GENERAL NOTES (FOR ALL P&ID EDITS):

- A. DRAWING NUMBERS CHANGED
- B. CLOUDS DENOTE ADDITIONS/ MODIFICATIONS.
- C. NOTES USED FOR REMOVALS + ASSUMPTIONS.
- D. MAIN FLOWS, VALVE TYPES AND SIZES PRIORITISED.
- E. LINE NUMBERS STILL IN PROGRESS.
- F. INSTRUMENTS/ALARMS BASED ON MAINTENANCE LIST.
- G. HAND SWITCHES & FAULT ALARMS FOR ALL MOTORS.

ASPECT										TENNANT MINING					PROJECT: TENNANT MINING PTY LTD NOBLES NOB GOLD MINE				
THIS DRAWING IS THE PROPERTY OF ASPECT ENGINEERING SOLUTIONS PTY LTD AND IS PRIVATE, CONFIDENTIAL AND IS SUPPLIED ON THE EXPRESS UNDERSTANDING THAT IT IS NOT TO BE USED FOR ANY PURPOSE OR COMMUNICATED TO ANY OTHER PERSON WITHOUT THE WRITTEN PERMISSION OF THE PROPRIETORS.										TITLE: REAGENTS PIPING AND INSTRUMENTATION DIAGRAM					SHEET A1 SCALE NTS DRG No. NNGM-100-PI-005 REVISION 0				
REV										DATE					DESCRIPTION				
DRAW										CHECK					DESIGN				
TECH APP										PROJ APP					REFERENCES				
DRG No.

PROJECT: TENNANT MINING PTY LTD NOBLES NOB GOLD MINE			
TITLE: PROCESS WATER AND AIR SERVICES PIPING AND INSTRUMENTATION DIAGRAM			
SHEET A1	SCALE NTS	DRG No. NNGM-100-PI-012	REVISION 0

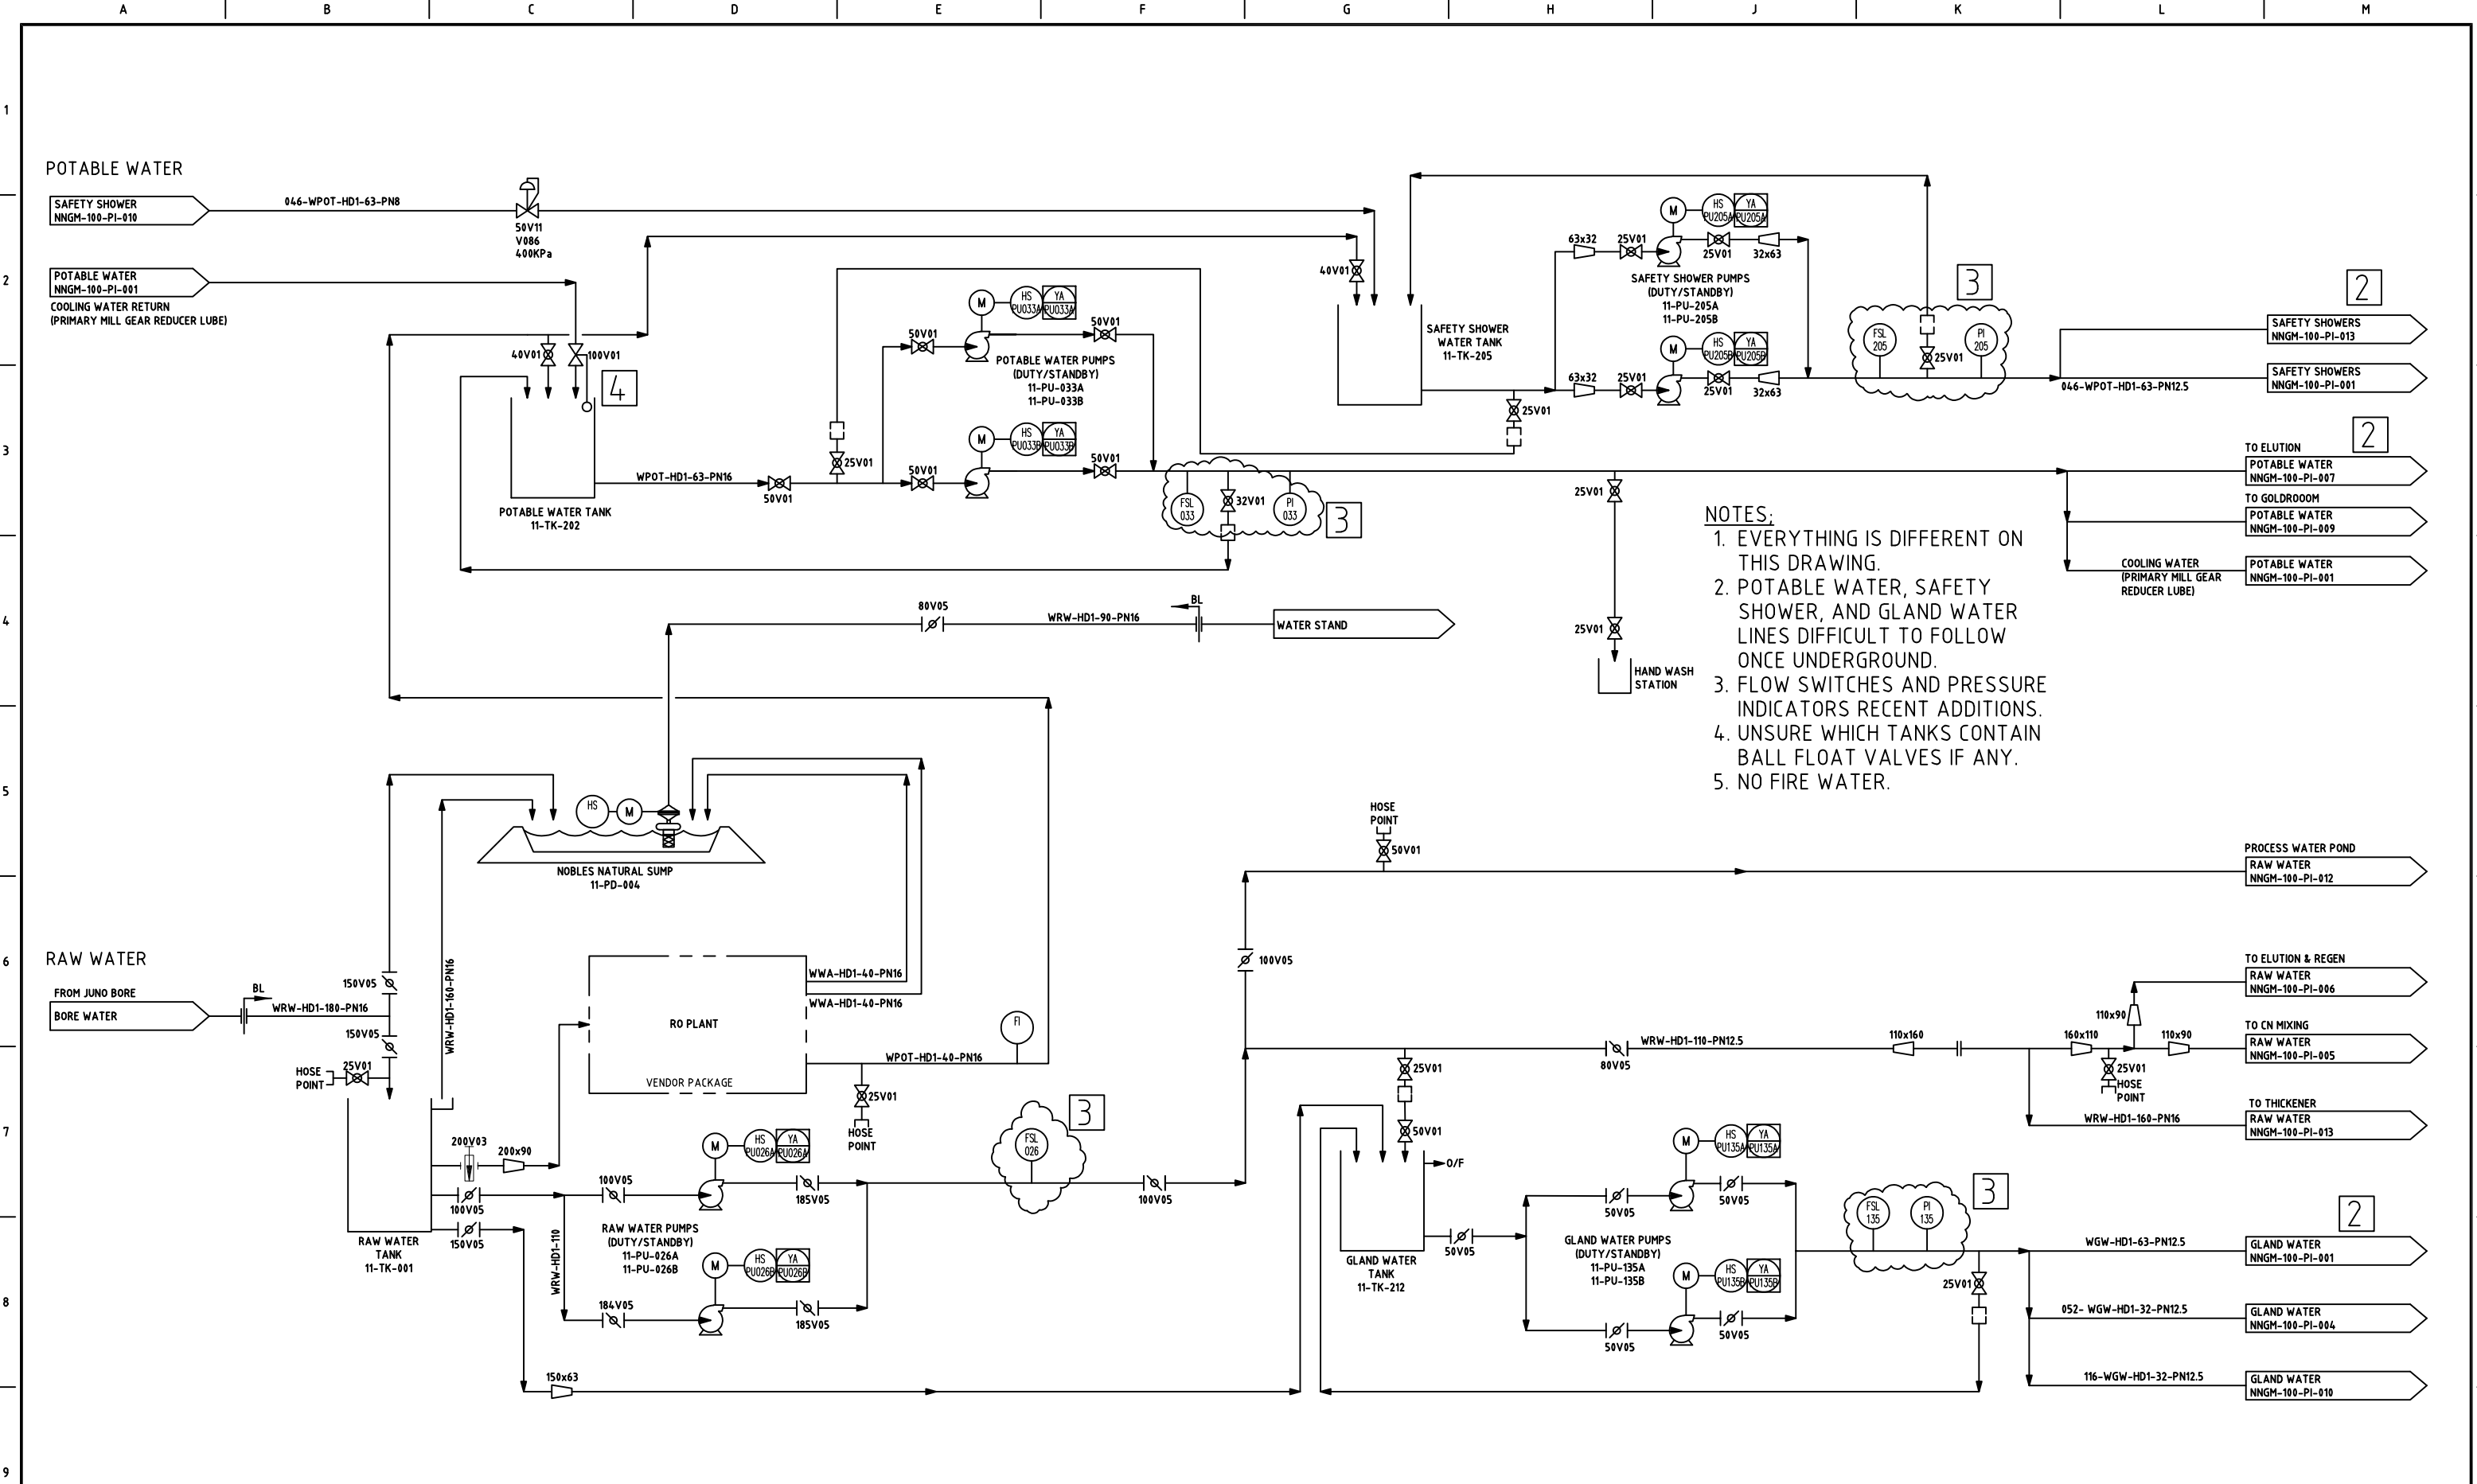
- NOTES:
- 1. EVERYTHING IS DIFFERENT ON THIS DRAWING.
 - 2. POTABLE WATER, SAFETY SHOWER, AND GLAND WATER LINES DIFFICULT TO FOLLOW ONCE UNDERGROUND.
 - 3. FLOW SWITCHES AND PRESSURE INDICATORS RECENT ADDITIONS.
 - 4. UNSURE WHICH TANKS CONTAIN BALL FLOAT VALVES IF ANY.
 - 5. NO FIRE WATER.

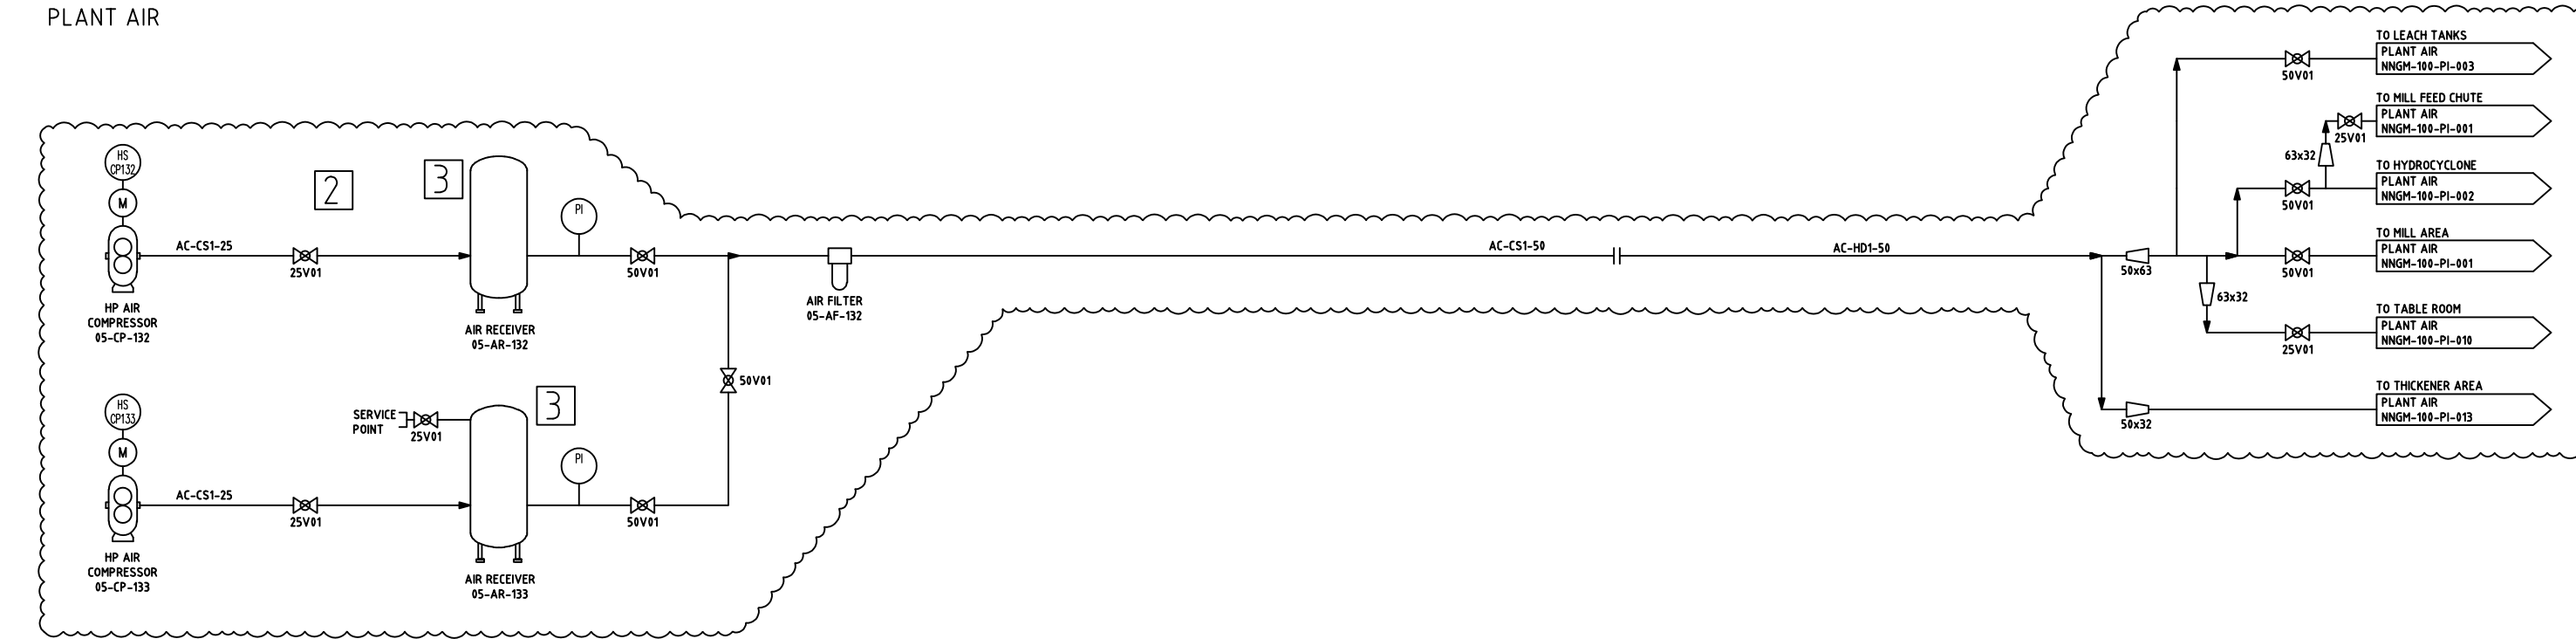
1. ANTISCALANT DOSING NOT CURRENTLY IN USE.
2. ALL AIR IS JUST PLANT AIR AND THERE ISN'T A SEPARATE AIR DRYER.
3. ALARMS ON AIR RECEIVERS REMOVED.
4. PROCESS WATER FLOW AND PRESSURE INSTRUMENTS + ALARMS NOT PRESENT.
